Dwelling type:	House and Garage.
Dwelling configuration:	Double Storey
Nature of works:	New Building.
Stage of inspection:	Pre Plaster.
Construction Type:	Multiple Claddings.
Garage:	Attached.
Foundations:	Slab.
Builder:

Schedule of Defects:

Defects, observations and other related comments from the Pre Plaster Inspection on the 08/04/2021:

DIAGRAM 4.08 BOTTOM PLATES THAT OVERHANG CONCRETE SLABS

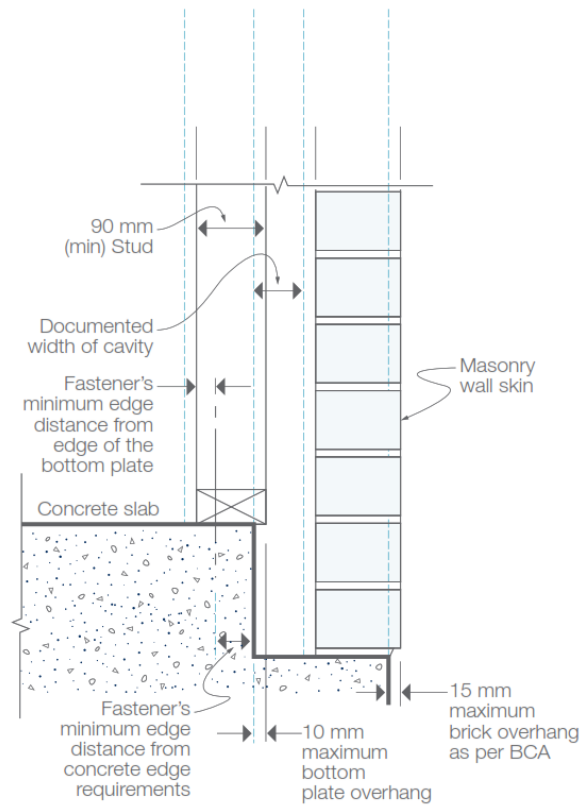
There is frame overhang to the slabs edge exceeding 10 mm noted to this dwelling. This defect has been highlighted with marking spray paint.

The Building Commission's Guide to Standards and Tolerances clause 4.08 Bottom Plates that Overhang Concrete Slabs, states '*Bottom plates that are at least 90mm*

wide and overhang concrete slabs are defective. An overhang of up to 10mm is permissible'.

This overhanging bottom plate will need to be supported by an appropriately designed and certified engineered system so that it complies with AS 1684.2, clause 6.3.3, and the BCA.

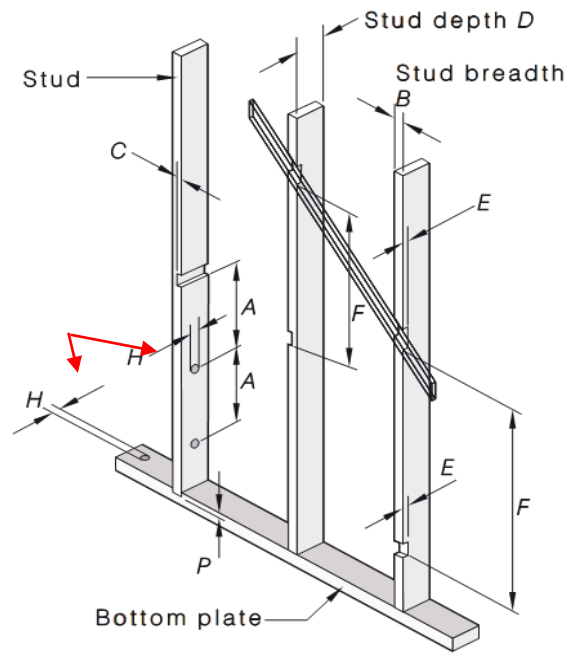
5.
AS 1684.2; Table 6.1: - Holes in timber studs and plates shall not exceed 25mm.

This requirement has not met this requirement.

Figure 11 Installation Summary

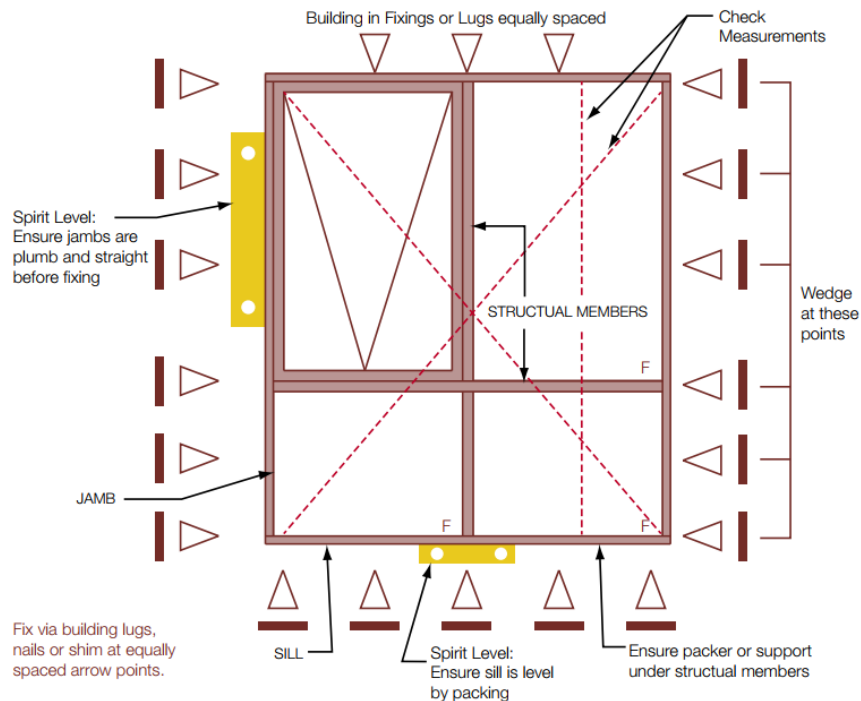
Australian Glass and Window Association (AGWA): - Windows shall be packed plumb and square including under the sill.

The window reveals and door frames around the dwelling have not been installed in accordance with the AGWA installation instructions or the manufacturer's installation instructions.

FIGURE 6.8 TOP PLATE STIFFENING

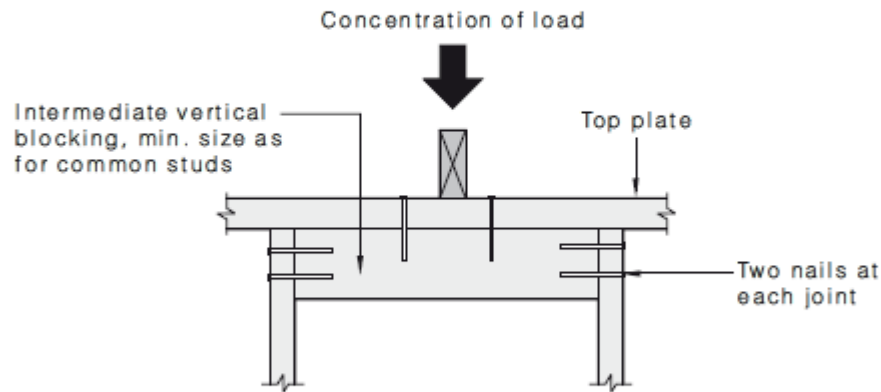
The top plates have been cut or drilled more than the allowance of AS 1684. Additional studs will need to be installed below the roof truss or floor joists to transfer the loading directly to the slab. Alternatively, the top plate could be stiffened as per the detail below.

6.2.2.3 Stiffening of top plates

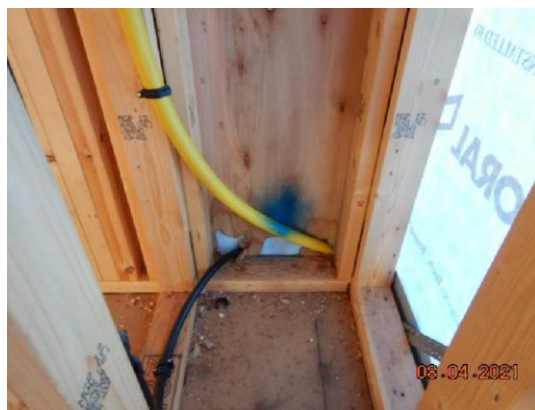
During construction, for various reasons, tradespeople often wish to make penetrations through structural plywood bracing panels. A neat hole (i.e., not over cut) of up to 100mm x 100mm within an envelope of 100mm from the vertical and top edges and 200mm of the bottom edge of the bracing pane will have no significant effect on the bracing capacity. Multiple 100mm x 100mm holes are allowable within the envelope but their centres must be no closer than 600mm.

One hole of up to 400mm x 400mm located between the studs and within the envelope defined above, with nogging framing the hole and fixing of the plywood to the framing as per the requirements for the top and bottom plate is acceptable.

All sheets failing the guidelines will need to be rework or replaced accordingly.

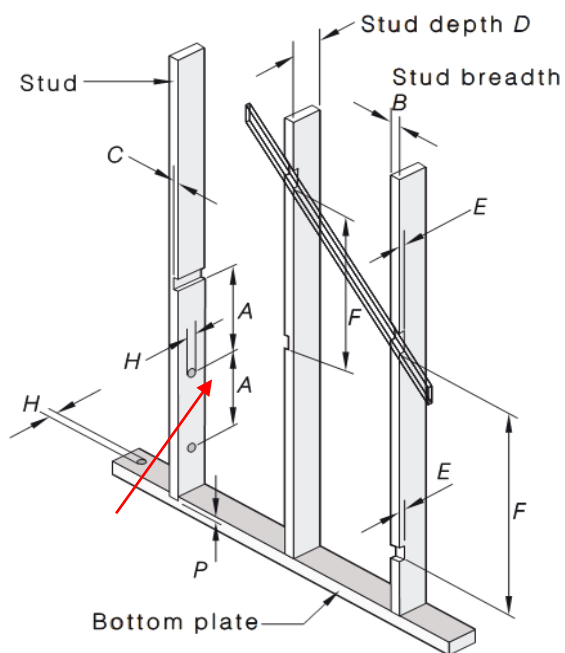
AS 1684.2; Table 6.1: - Holes and / or notches in studs shall be spaced minimum 3 x D apart.

This requirement has not met this requirement.

FIGURE 2.5.2(D) FLEXIBLE DUCT INSTALLATION—RADIUS BENDS

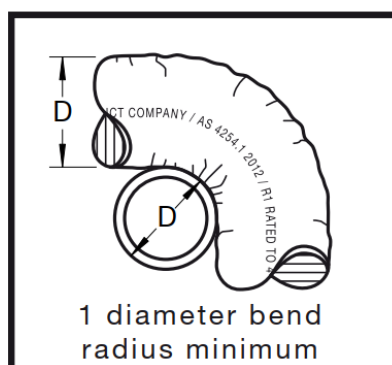
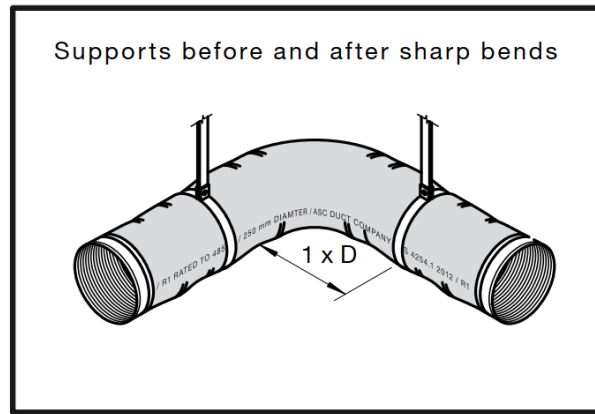
AS 4254.1; 2.5.3 (i): - Flexible ducts shall be installed with a bend radius to duct diameter ratio of 1 to 1, as a minimum.

There are bends to flexible ducts that have not met this requirement.

FIGURE 2.9 STUD/PLATE LAMINATION

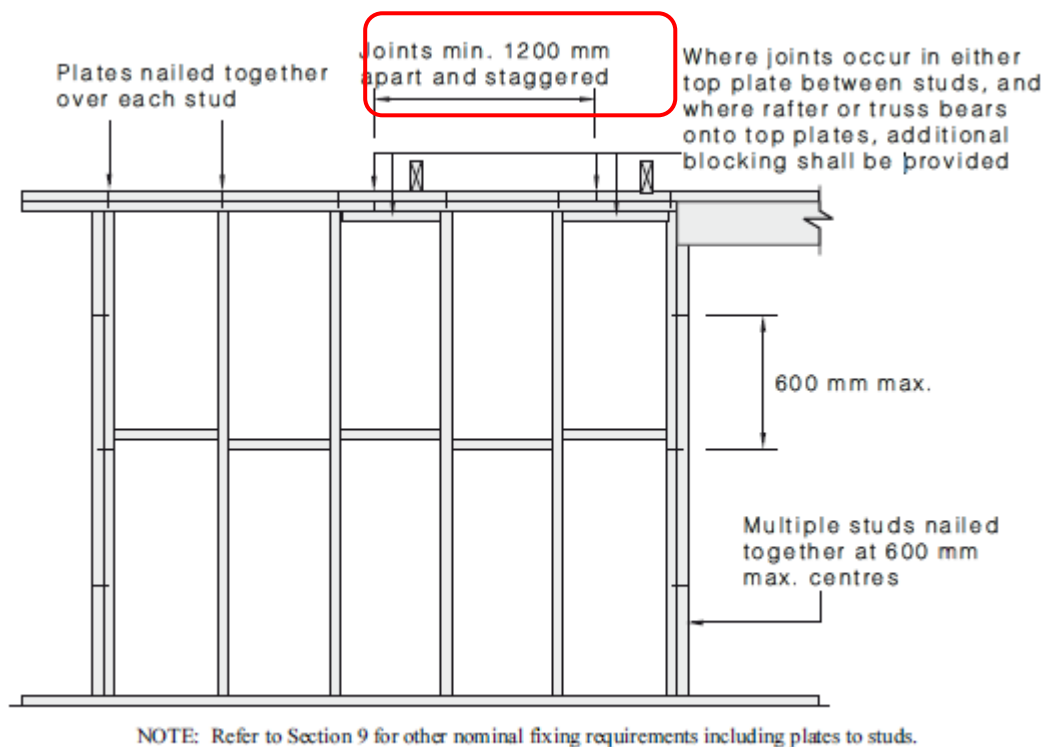
AS 1684.2; 2.4: - Joints in laminated top plates are required to be a minimum of 1200 mm apart.

Joints in the top plates were found to be spaced less than 1200 mm

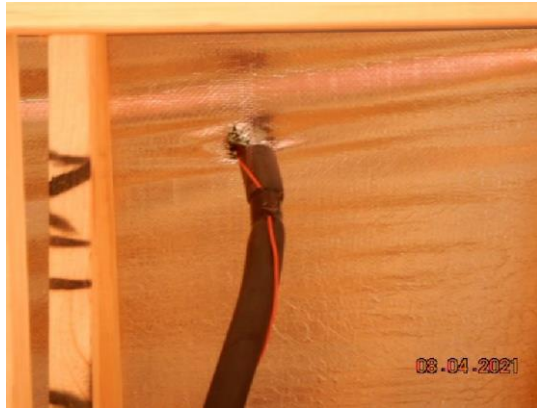
The sarking under the roof has been cut around the roof penetrations. All areas must present sealed to an acceptable finish to comply with the energy rating requirements of the home.

Note; if the home has a BAL rating of 12.5 or over then the sarking will need to be sealed to a gap of no more than 3mm in this installation.

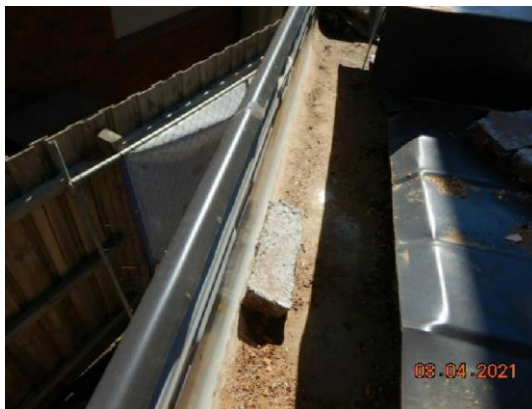
AS 3700: - The effect of any chases, holes and recesses required in the masonry shall be considered in the design to ensure that the masonry achieves the required performance.

The cutting of brickwork to this dwelling is deemed to not comply with this requirement.

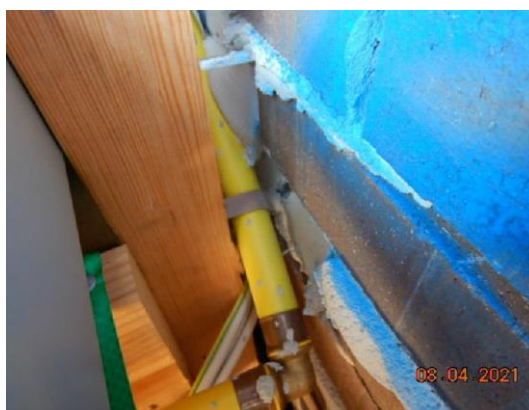
NCC 2019: - The clear width of the cavity must be not less than 25mm and must be maintained regardless of any wall membranes, sheet bracing or the like installed to the supporting frame.

Clear widths less than 25mm between the masonry veneer and installed services are non-compliant.

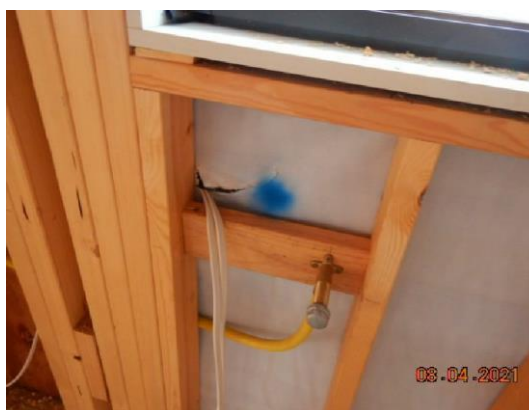
Multiple sections to the wall wrap that require reinstating due to rips, tears, and openings.

All defective areas reworking as per the requirements of AS 4200.1, the manufacturer's installation guide and this dwellings energy report.

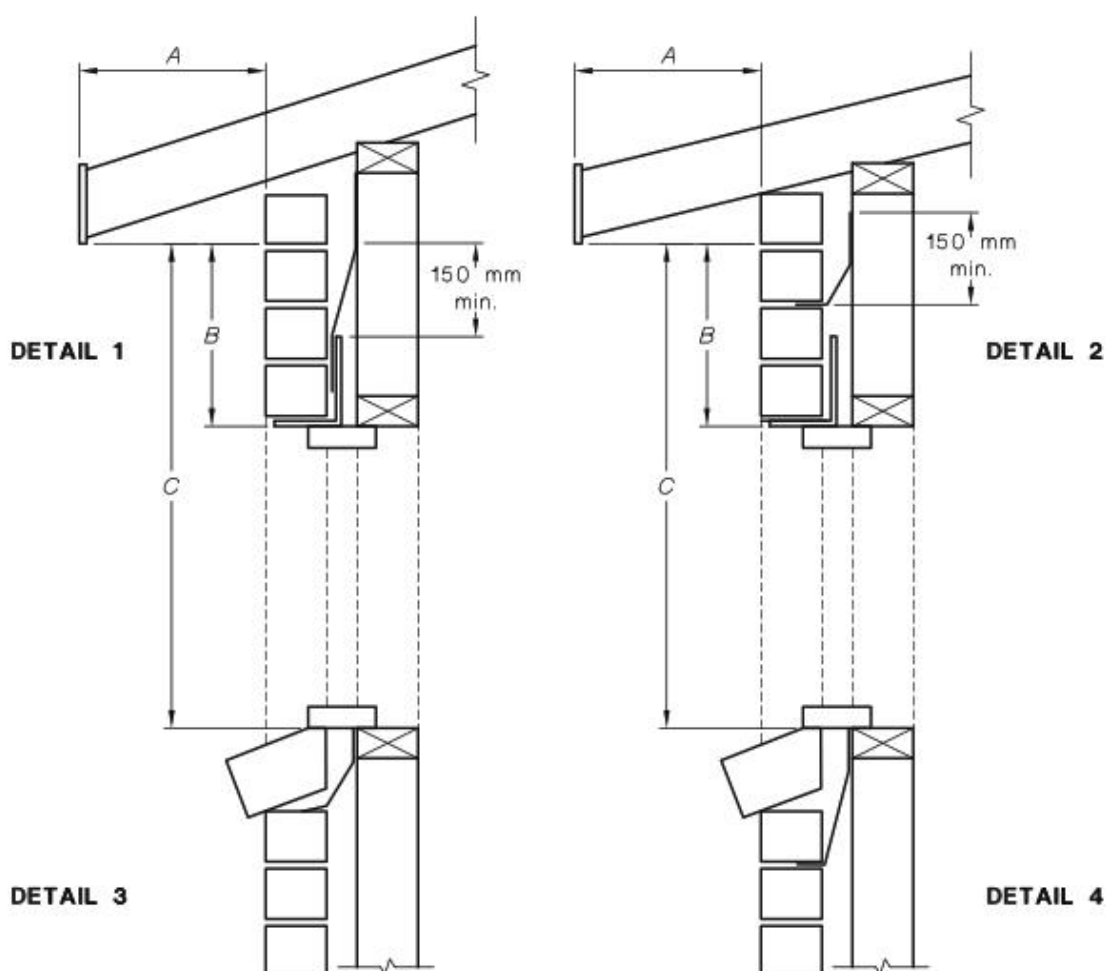
It was noted that no sill flashings have been installed to the underside of the windows. The BCA calls for compliance with AS 4773.2. This Standard calls for sill flashings. It is not an obscure requirement but rather a requirement that is clearly defined and well presented in AS 4773.2, part 10.5.3.2.

The bricklayer will need to ensure that all flashings are installed to the minimums set out in the Standard.

FIGURE 9.1 FLASHING AT CORNERS

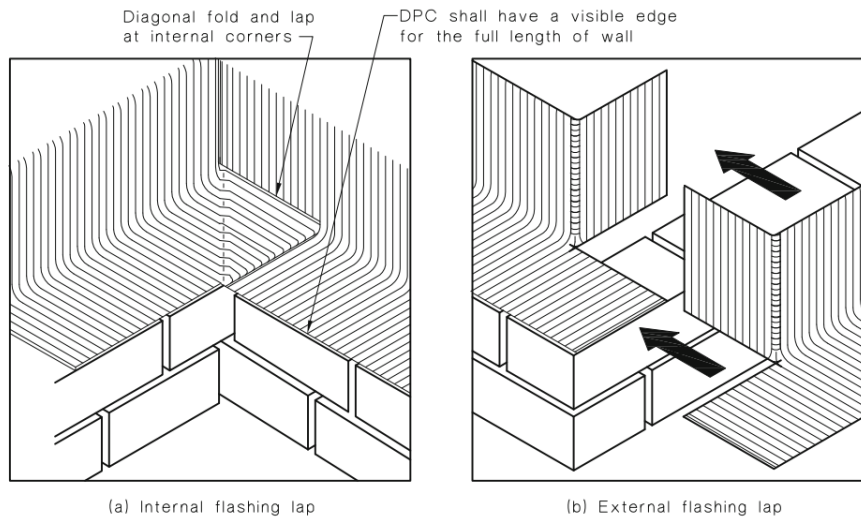
AS 4773.2: - Cavity flashings in a straight run shall be lapped at joints by a minimum of 150mm. Cavity flashings at corners shall be lapped by the width of the leaf and cavity (see Fig. 9.1).

Damp proof course flashings to this dwelling do not meet this requirement.

FIGURE 6.3 TYPICAL WALL JUNCTIONS

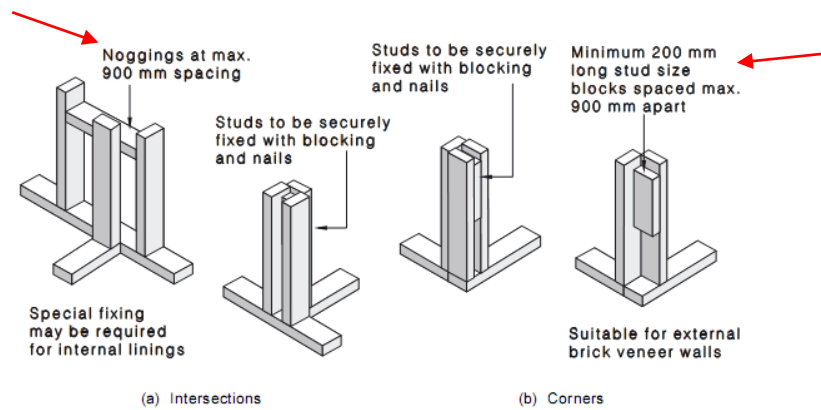
AS 1684.2; 6.2.1.3: - Corner blocks (and nogging, where applicable) to intersecting walls shall be spaced not more than 900mm apart.

A few intersecting walls have insufficient or missing blocks.
